Fargo VAMC – Refurbish Elevators and Replace Controls

Fargo, North Dakota
Project #19-2481

MARCH 26, 2024

ADDENDUM NO. 2

Project Number	437-22-101
Building Number	1,946
Drawing Number	A5.20
Date	12.20.22
Checked	JS
Drawn	JE
Dwg.	10 of 41

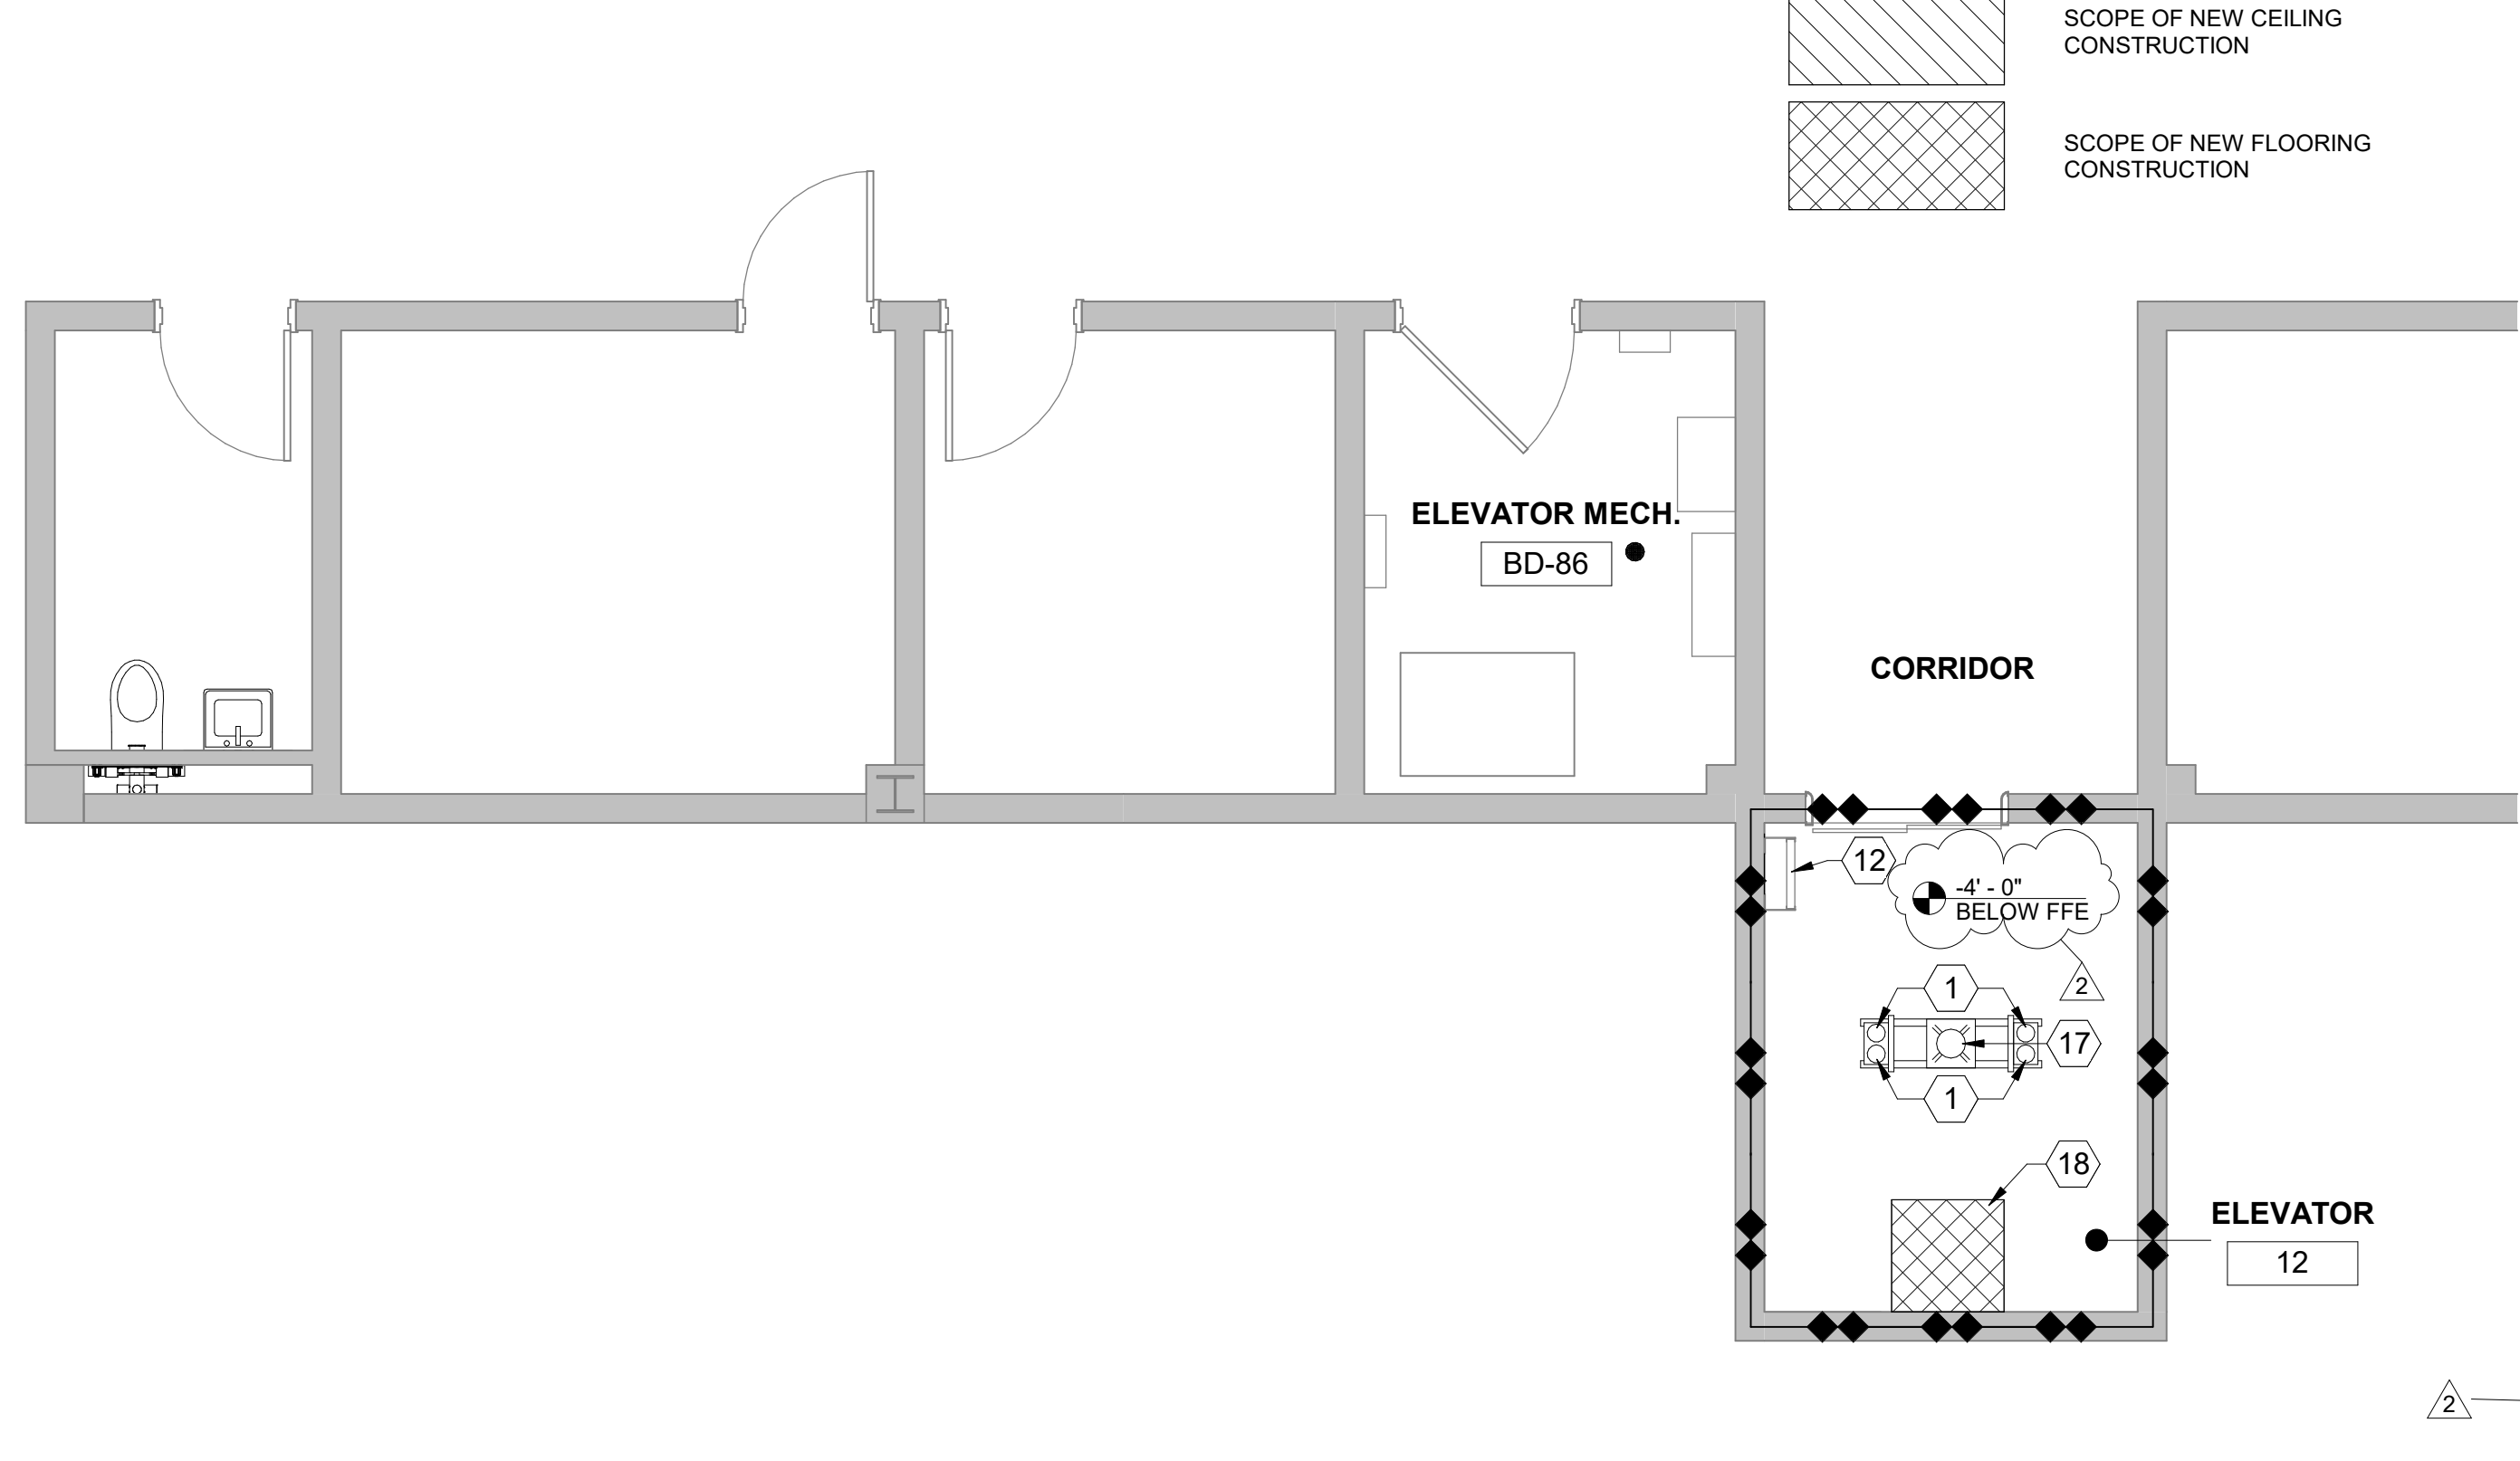
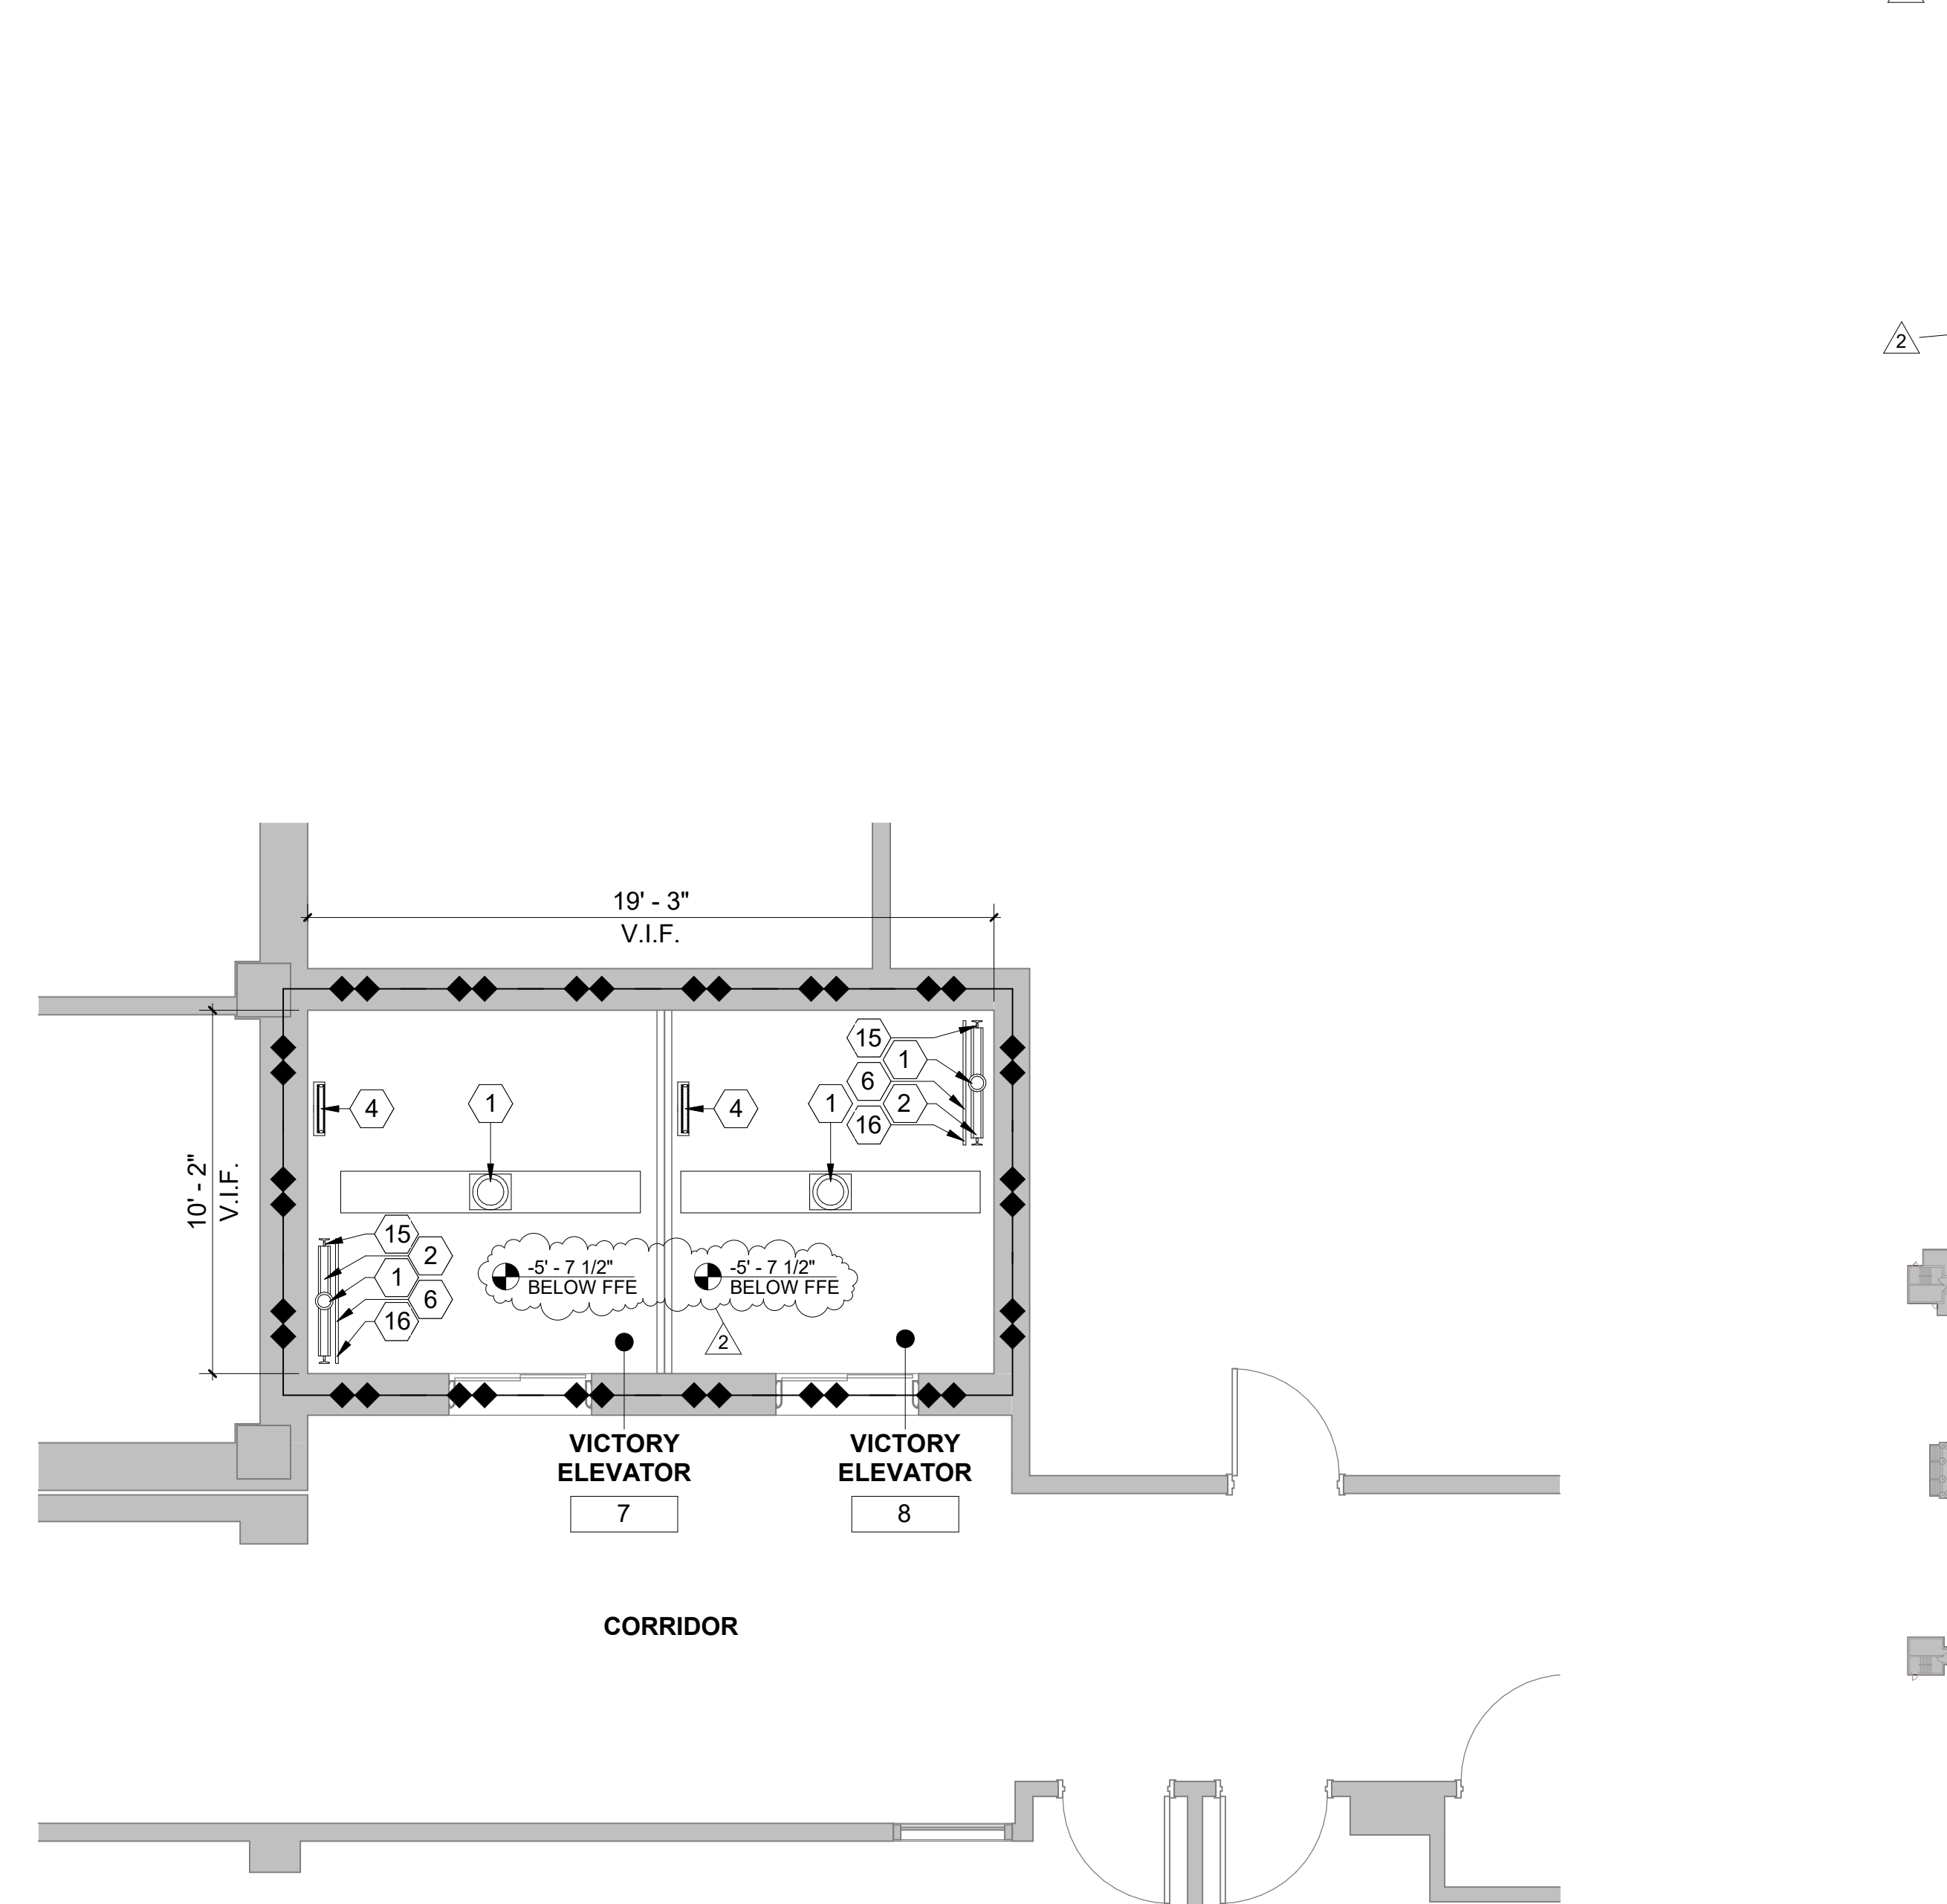
Drawing Sheet A5.20 ENLARGED PLANS – ELEVATOR PITS – See revised drawing sheet for the adjustment of keynotes # 3, 9, 15, 16, 17. Also included is the depth of each elevator pit relative to the floor elevation at the lowest elevator lobby for each hoistway.

11. RESILIENT TILE FLOORING. SEE SPECIFICATIONS.
12. NEW LOWER SECTION OF GUIDE RAILS (APPROX 20 LF AT EACH RAIL. INSTALL TO COORDINATE WITH OTHER NEW EQUIPMENT. PROVIDE NEW MOUNTING BRACKETS. APPLIES TO ELEVATOR 7 AND 8 ONLY DUE TO WATER DAMAGE.

13. NEW LOWER SECTION OF COUNTERWEIGHT RAILS (APPROX 20 LF AT EACH RAIL AND PIT GUARD. INSTALL TO COORDINATE WITH OTHER NEW EQUIPMENT. PROVIDE NEW MOUNTING BRACKETS. APPLIES TO ELEVATOR 7 AND 8 ONLY DUE TO WATER DAMAGE. EXISTING HYDRAULIC PISTON JACK TO BE REUSED. REPACK ENTIRE ASSEMBLY.
